# City of Cedar Rapids Historic Preservation Commission

To:Historic Preservation Commission MembersFrom:Adam Lindenlaub, Community Development PlannerSubject:COA Request at 1615 2<sup>nd</sup> Ave. SEDate:November 5, 2020

To:Historic Preservation Commission MembersFrom:Jeff Wozencraft, Community Development PlannerSubject:Demolition Request at 1812 Blake Blvd SEDate:November 5, 2020

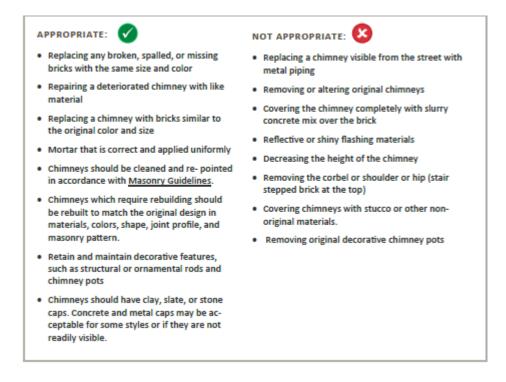
The applicant's chimney was completely knocked down during the August 10<sup>th</sup> storm and they would like to not rebuild the chimney which is at the rear of the house. The applicant will repair the roof where the chimney exited when they re-roof the rest of the house and vent their hot water heater out the foundation at the side of the house.

**Staff Recommendation:** Staff recommends approving the request as the chimney was completely destroyed and is located at the rear of the house. Since no other part of the chimney is exposed it would look like it never had one. The State Historic Preservation Officer was consulted and she stated that there is no requirement to put back an architectural element that is gone or has been destroyed.
